LRN-01-0052
LCR H00-05, Sup. 1

**SUPPLEMENTAL INFORMATION FOR
REQUEST FOR LICENSE AMENDMENT
INCREASED LICENSED POWER LEVEL
HOPE CREEK GENERATING STATION
FACILITY OPERATING LICENSE NO. NPF-57
DOCKET NO. 50-354**

CALC NO.: H-1-BB-NDC-1858 REVISION: 01R0		CALCULATION COVER SHEET		Page 1 of 9	
CALC. TITLE:		Reactor Vessel Fluence Calculation for 1.5% Power Uprate			
# SHTS (CALC):	9	# ATT / # SHTS:	1 / 1	# IDV/50.59 SHTS:	1
		# TOTAL SHTS:	11

Figure 3.4.6.1-1
Hydrostatic Pressure and Leak Tests Pressure/Temperature Limits - Curve A

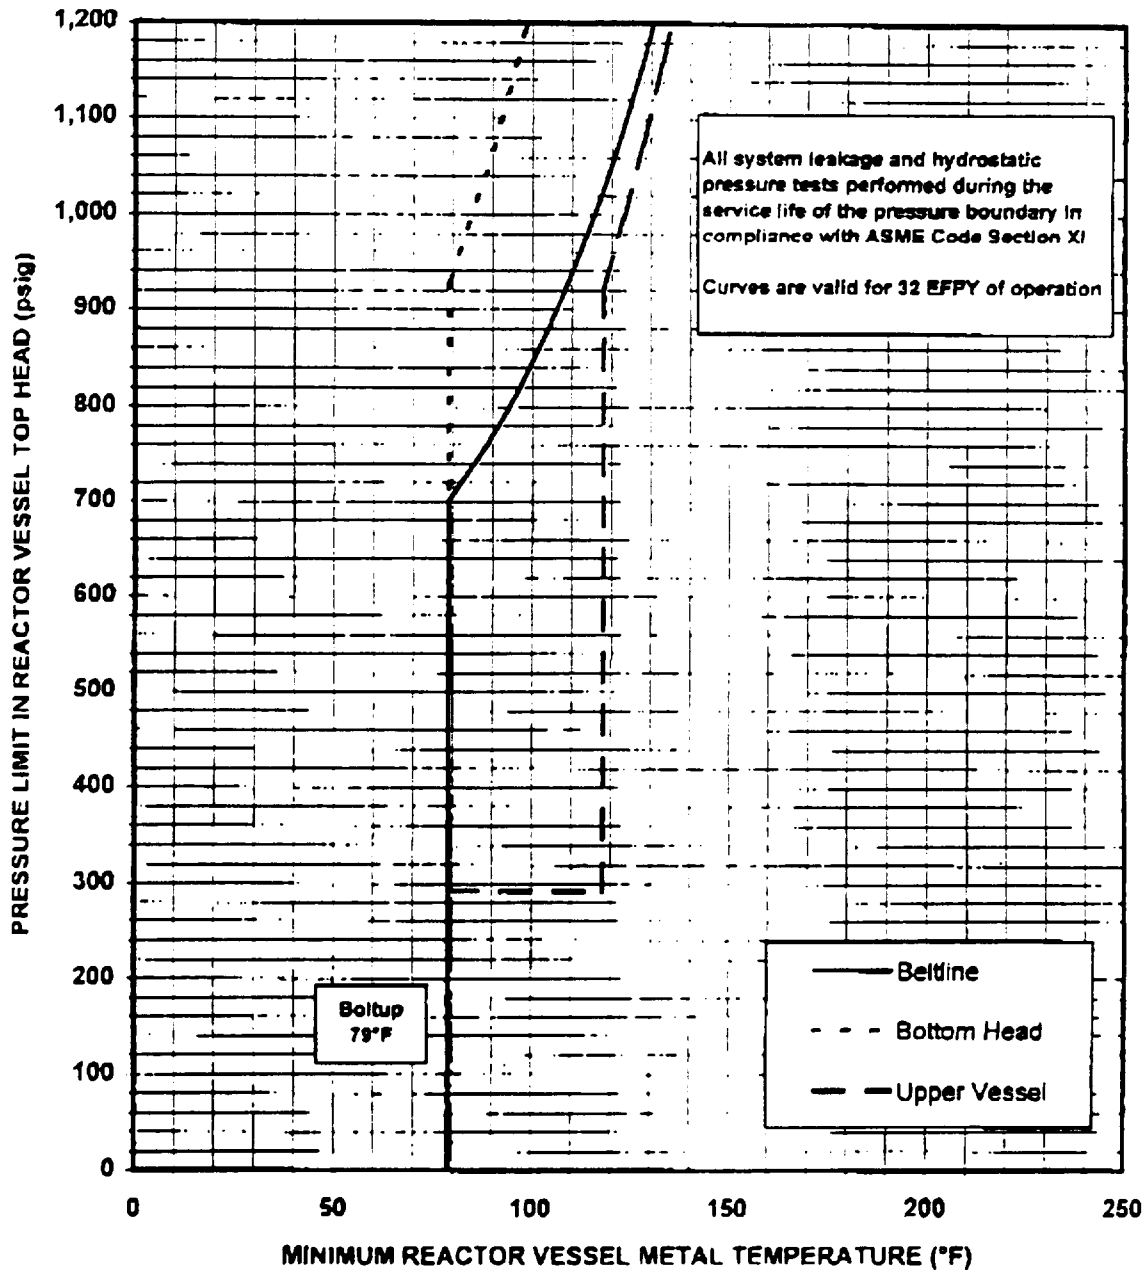
In a teleconference between members of the NRC and PSEG Nuclear on February 2, 2001, the NRC indicated that the neutron fluence used to develop the revised P-T curves did not reflect the guidance contained in Draft Regulatory Guide DG-1053, "Calculational and Dosimetry Methods for Determining Pressure Vessel Neutron Fluence," and therefore the NRC could not support approval of the new P-T limits out to 32 Effective Full Power Years (EFPY). Since there are no currently NRC approved methods that follow the guidance of DG-1053, PSEG Nuclear requests that the curves submitted on December 1, 2000 be approved for use until the end of Hope Creek Cycle 11 (currently scheduled to end in April 2003). This will allow continued operation of Hope Creek until methods are approved by the NRC that follow the guidance of DG-1053. Attachment 1 provides the revised marked-up pages of figures 3.4.6.1-1, 3.4.6.1-2, and 3.4.6.1-3 with a note that states that the new P-T curves are only valid until the end of Hope Creek Cycle 11. Please replace the revised P-T curves contained in the December 1, 2001 submittal with the P-T curves contained in Attachment 1 of this submittal.

Note: This figure is valid through Cycle 11 Operation in accordance with NRC Safety Evaluation Report supporting Amendment No. _____
